CITY OF FRESNO – ADDENDUM NO. 2

RIVER WEST FRESNO EATON TRAIL EXTENSION, PHASE 1

BID FILE NUMBER: 12700455

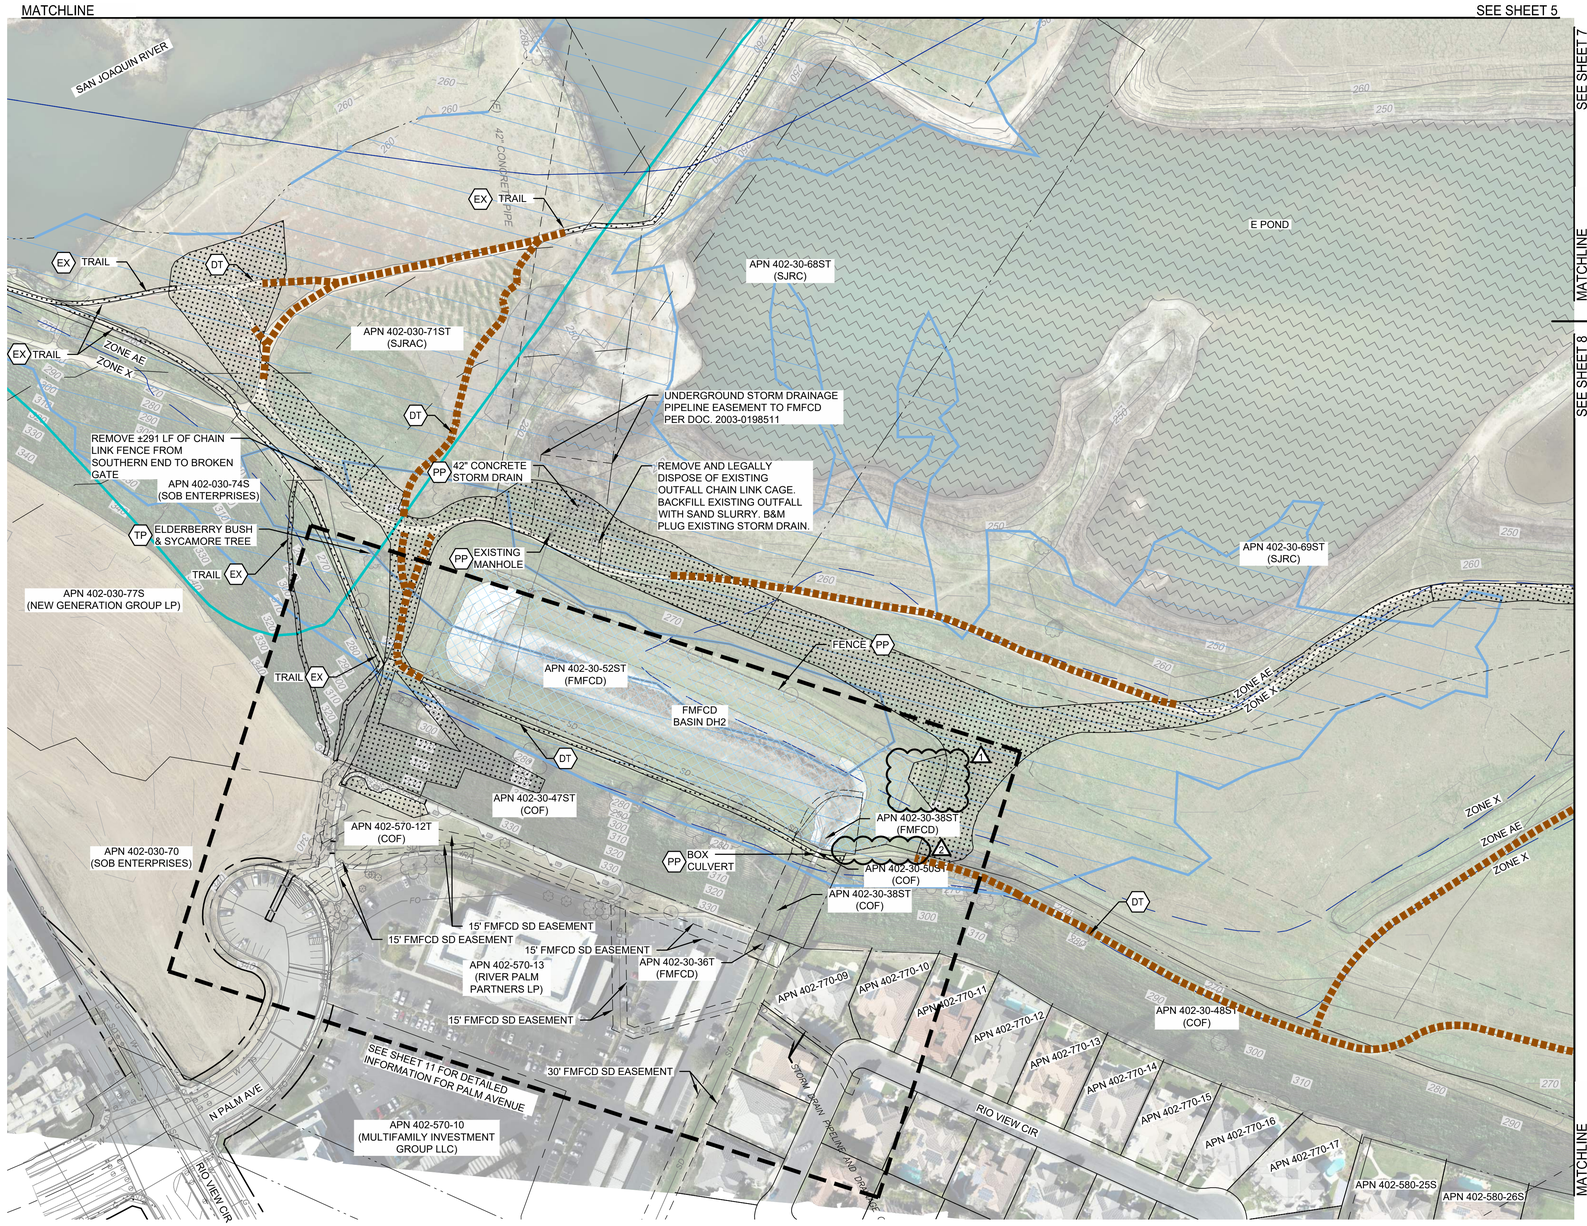
6. Modification to the FMFCD access ramp and embankment surfacing on Sheet 15-E-14617:

- Remove and Replace Sheet No. 15-E-14617, Sheet 36 of 133, entirely with Addendum No. 2 Drawing Sheet No. 15-E-14617 (Addendum No.2), (clouded and marked ADDENDUM NO. 2) which updates the FMFCD access ramp and embankment surfacing to hydroseeding per project specifications.

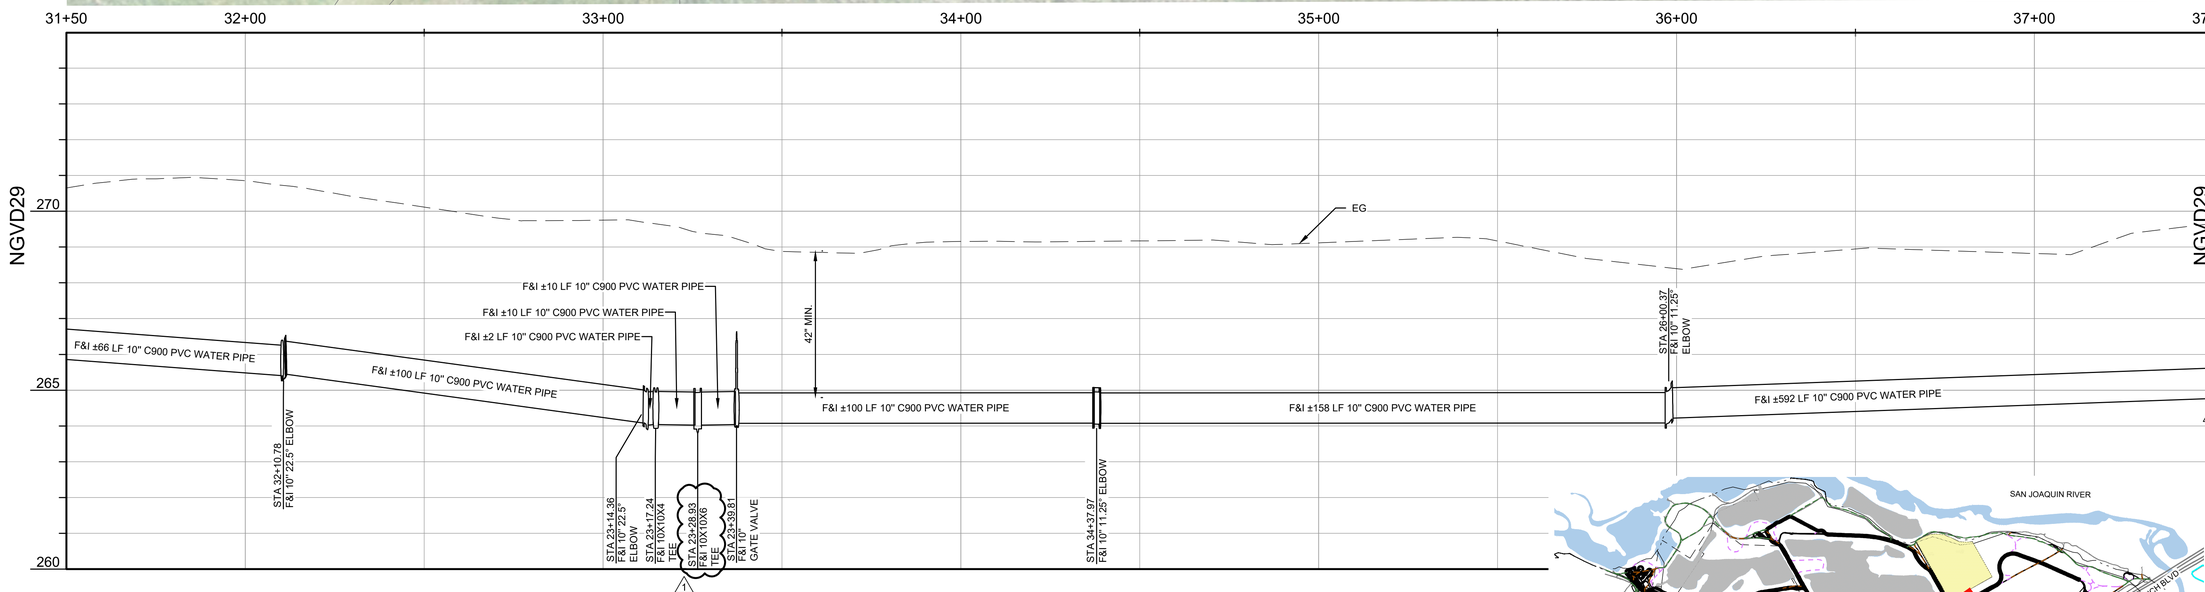
7. Modification to the water service line and irrigation connections on Sheet 15-E-14638:

- Remove and Replace Sheet No. 15-E-14638, Sheet 57 of 133, entirely with Addendum No. 2 Drawing Sheet No. 15-E-14638 (Addendum No.2), (clouded and marked ADDENDUM NO. 2) which updates the following:

- ~~-~~ Modification of Backflow prevention device callout. F&I NEW 10" BACKFLOW PREVENTION DEVICE ~~**WITH LOW-FLOW BYPASS METER. LOW FLOW BYPASS METER SHALL HAVE AN INTEGRATED RP DEVICE.**~~ **SEE NOTE 5**~~"~~
  - Modification of irrigation connection shown, by adding a **2" METER WITH METER BOX.**
  - **Modification to irrigation connection, by adding note: "IRRIGATION LINES ARE TEMPORARY AND ARE TO BE CAPPED 5 YEARS AFTER COMPLETION OF CONSTRUCTION. A PERMIT IS REQUIRED TO CAP TEMPORARY IRRIGATION LINES. – NOT A PART OF THIS CONTRACT."**
